PILATUS AIRCRAFT LTD. CH-6371 STANS, SWITZERLAND

SERVICE BULLETIN

SERVICE BULLETIN NO: 28-008

FUEL - DISTRIBUTION ENGINE DRIVEN PUMP - TORQUE CHECK OF RELIEF-VALVE-BODY SCREWS

Torque Check and Fuel Leak Inspection of the EDP
Figure 1

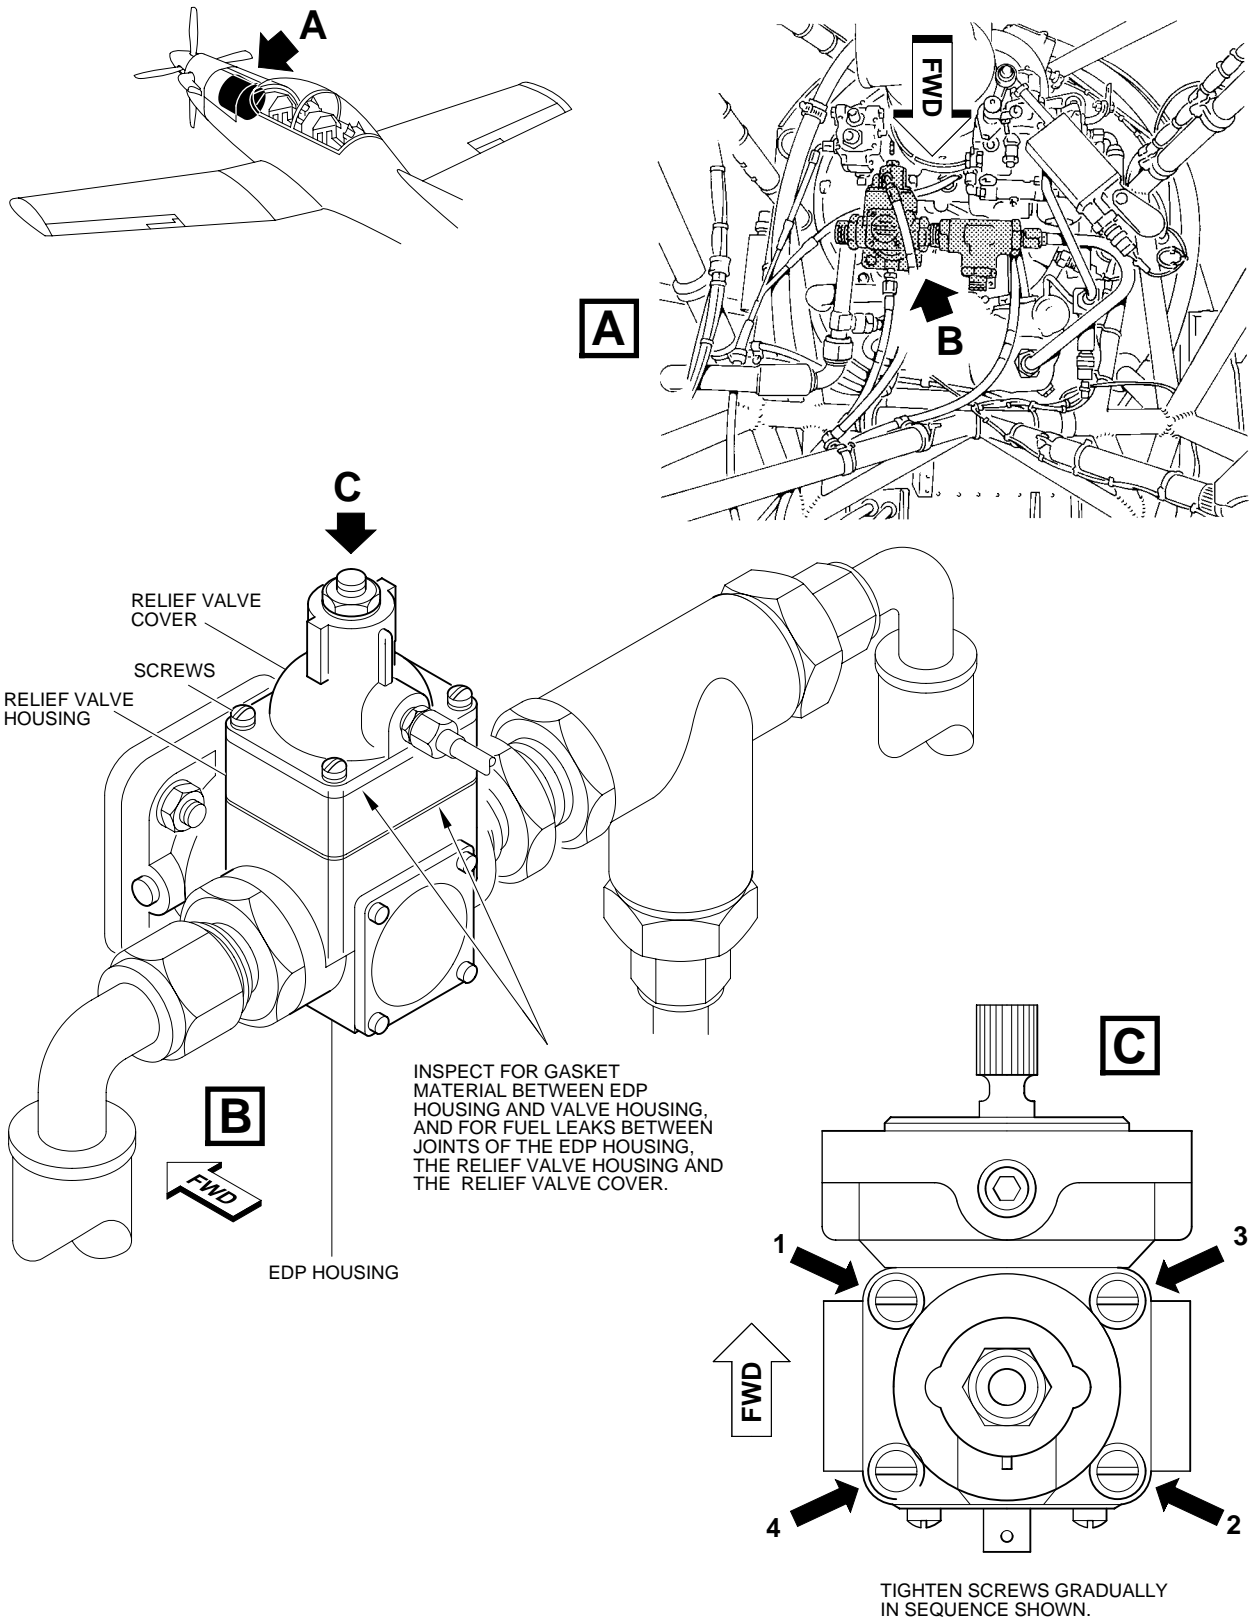
- (1) Visually inspect the joints between the EDP housing, relief valve housing and the relief valve cover for:
 - Fuel leakage
 - Gasket material pushed out

- (2) If the EDP shows signs of fuel leakage or the gasket between the EDP housing and the relief valve housing has been pushed out, replace the EDP (Ref. AMM, 28-20-10, Page Block 401).

- (3) Use a torque screwdriver to do a check of the torque value of the relief-valve-cover screws. Do the check clockwise only. The minimum torque must be 23 lbf in. (2,6 Nm).

- (5) If the relief-valve-cover screws are loose, or the torque found at Step (3) is less than 23 lbf in. (2,6 Nm), do as follows:

- (b) Torque the screws gradually to between 23 and 25 lbf in. (2,6 and 2,83 Nm). Do this in the sequence shown in Figure 1, Detail B.

- (a) Cut, remove and discard the lockwire that safeties the relief-valve-cover screws.

- (c) Safety the screws with lockwire (Material Item P02-001).
